RALEIGH & KIRKMAN MIXED USE W. DRIVE-THRU

<p>Owner Hiawassee, Inc.</p> <p>Applicant Brent Lenzen, PE Kimley Horn & Assoc.</p> <p>Project Planner Jim Burnett, AICP</p> <p>Updated: July 11, 2022</p>	<p>Property Location: 5641 Raleigh Street (northeast corner of Raleigh St. and S. Kirkman Rd.) ($\pm$1.10 acres, District 5)</p> <p>Applicant's Request: The applicant is proposing to construct a new $\pm$8,650 sq. ft. multi-tenant retail/restaurant building with a drive-through, requiring a Master Plan (MPL2022-10049) and a Conditional Use Permit (CUP2022-10011) for the drive-through of the proposed restaurant space. A similar Master Plan & CUP was approved in 2019 but subsequently expired before permits could be issued.</p>	<p>Staff's Recommendation Approval of the Master Plan and CUP requests, subject to the conditions in this report.</p> <p>Public Comment Courtesy notices were mailed to property owners within 300 ft. of the subject property during the week of July 5, 2022. As of the published date of this report, staff has received no comments regarding the request.</p>

The applicant is seeking to develop the currently vacant site with a ±8,650 sq. ft. multi-tenant retail / restauran

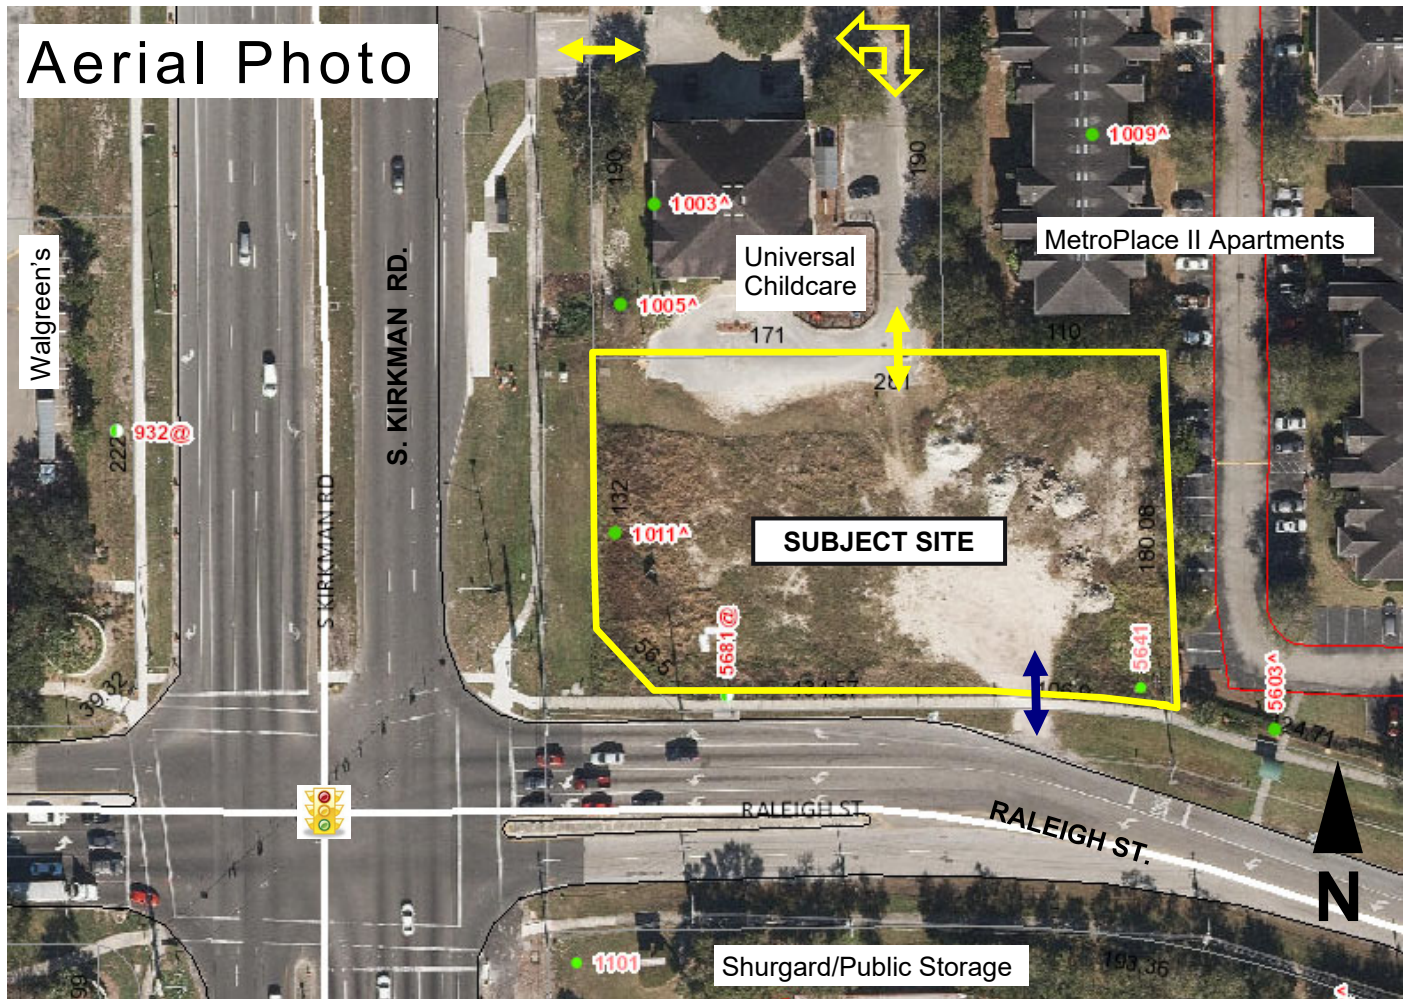
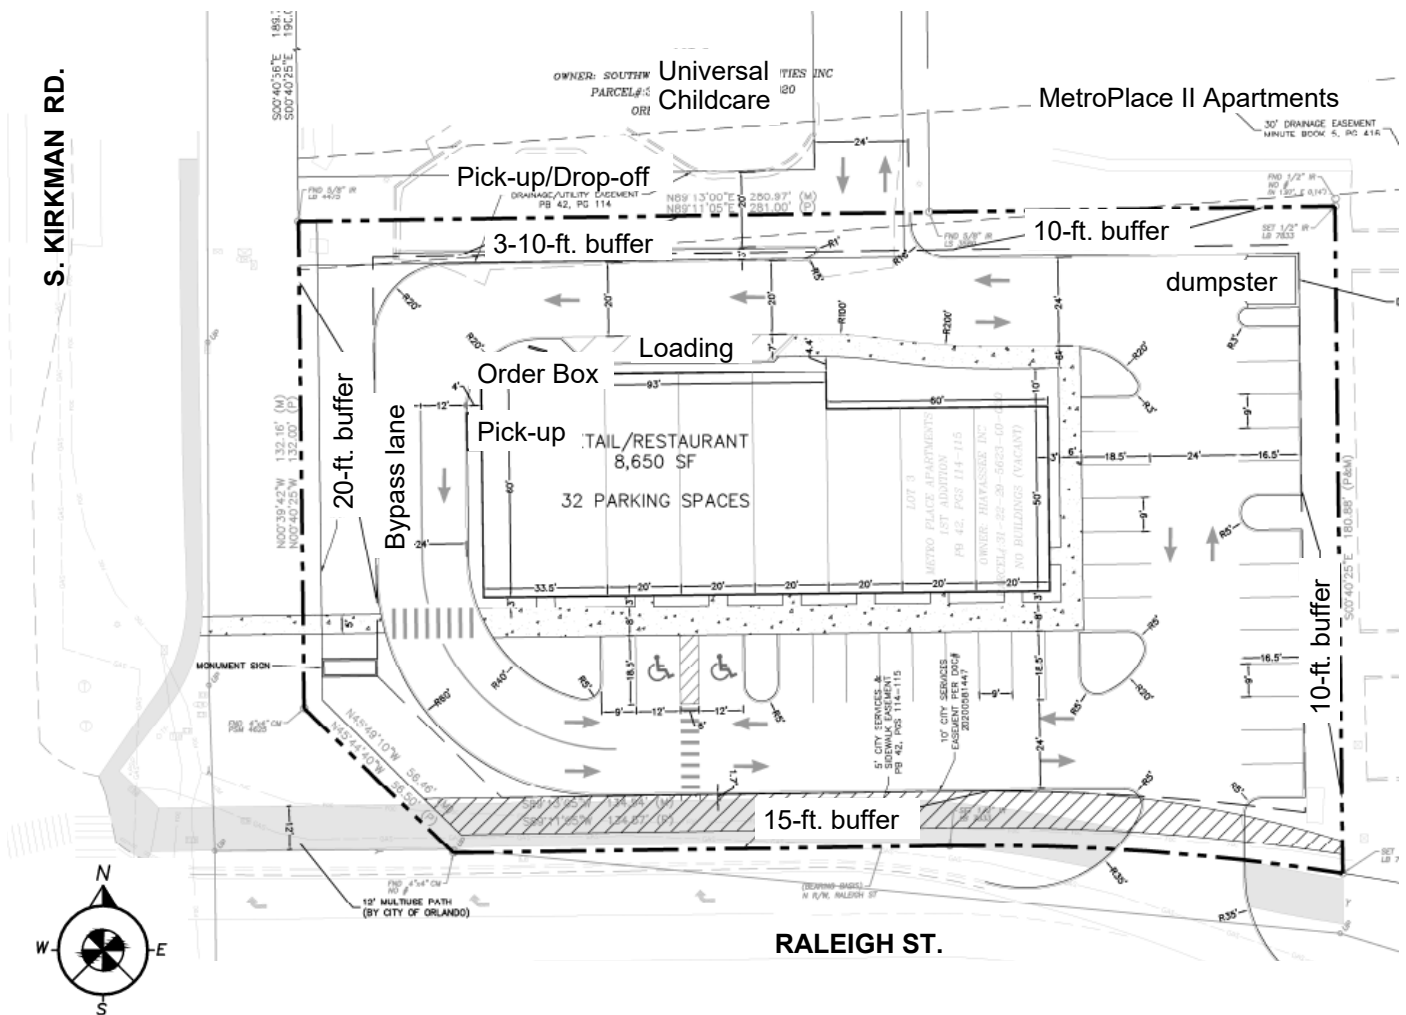
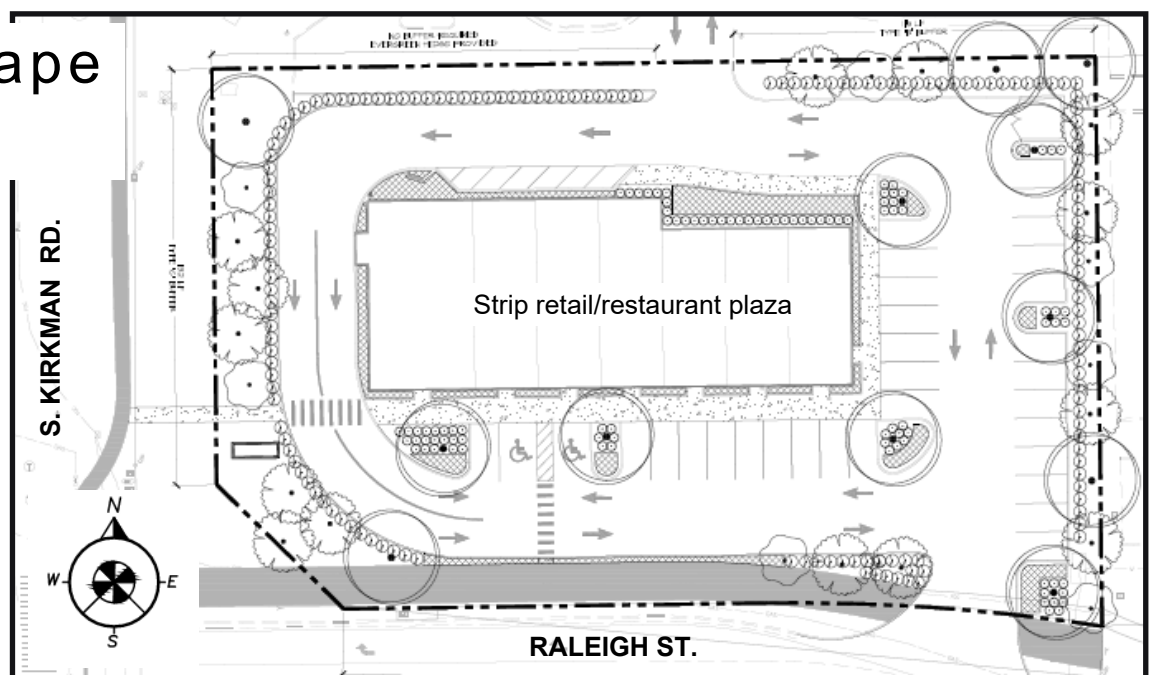
1. Paved or concrete access walkways must be added from the loading zone to the rear doors and must be added to the plans prior to permitting. Both the landscape and site plans must be revised to address this.

14. The landscape island in the northeast corner needs to be increased to a minimum of 10 ft. width, which may result in the loss of a parking space immediately adjacent to the landscape island.

15. Canopy trees are required in all row end and intermediate parking lot landscape islands.
 16. The southern drive aisle must be reduced to 23 ft. wide. A hedge must then be installed between the bike trail and the edge of the parking lot.

5. The eastbound lanes on Raleigh St may not be shifted as shown on this submittal. Instead, the inside lane must be restriped as a left turn drop lane. All appropriate pavement markings and signs must be provided by the developer.

Proposed Elevations

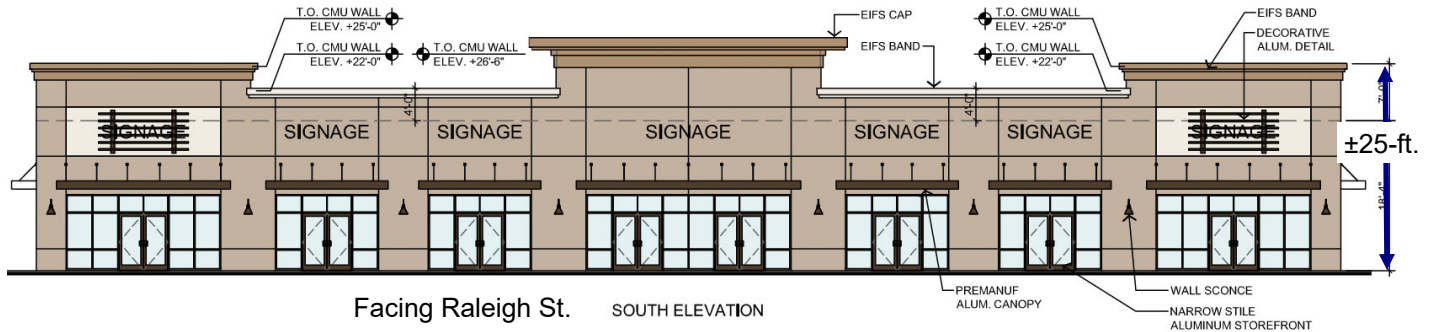
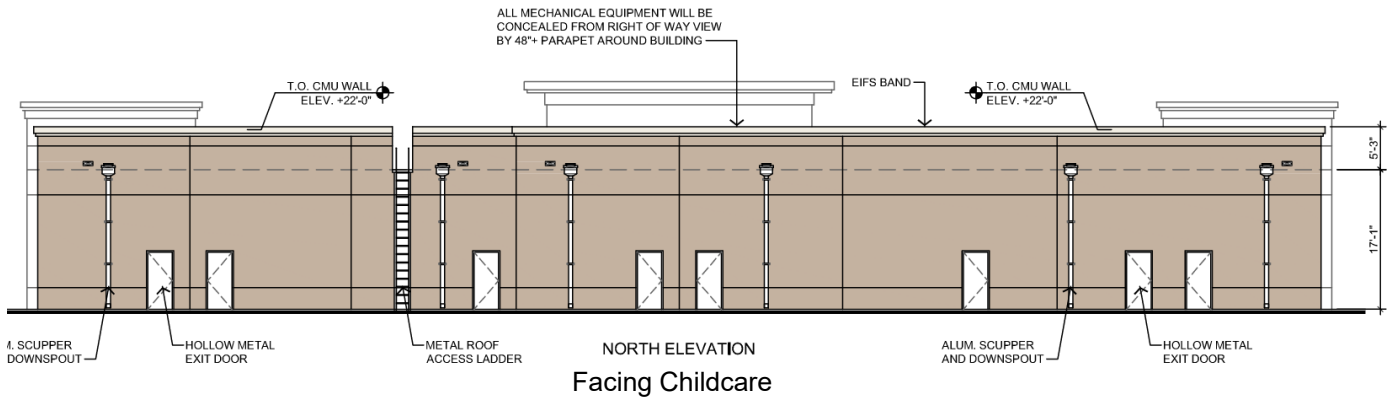
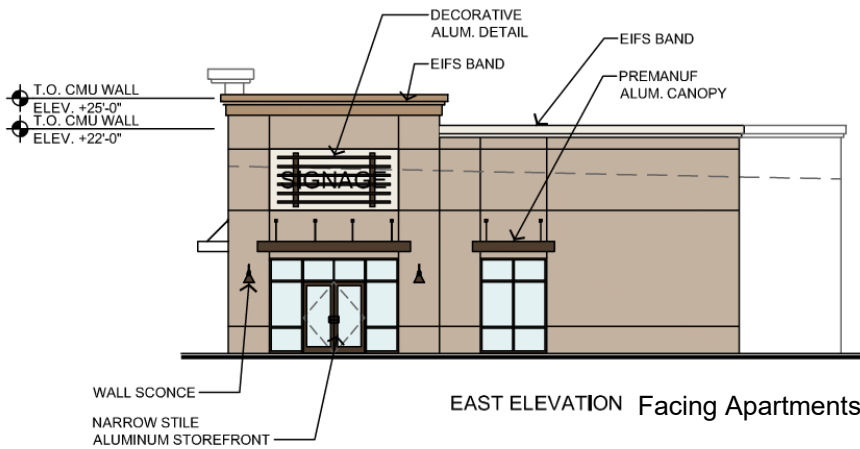
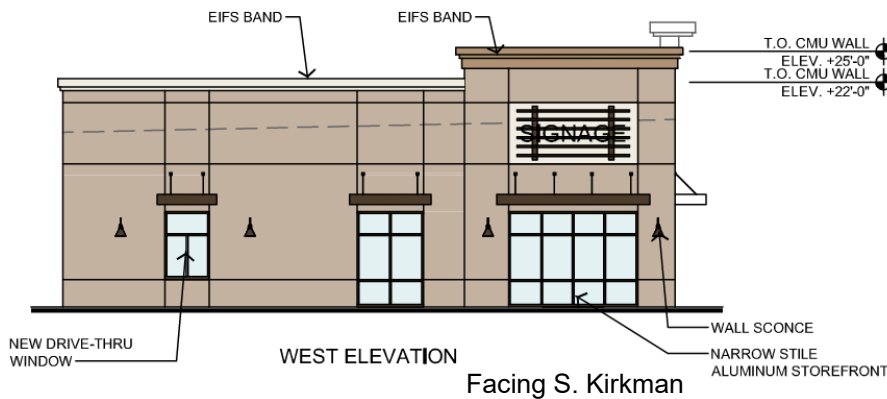
Total sign area is limited to **300 sq. ft.**, to be spread among however many tenant uses there are. Total # of signs may need to be reduced.

11. The parapet tower features must return a minimum of 5 ft. into the building to provide a finished, 3-dimensional appearance.
 12. The central parapet may remain as designed in depth but must be finished and painted along both the sides and back to provide a finished appearance.

13. The drive through "pick up window" as shown in the site plan appears to bump out from the building but this is not reflected in the building elevations provided; thus, the elevations must be updated at time of permitting. The sides of the bump-out must be finished to the same finish and detail as the rest of the building.
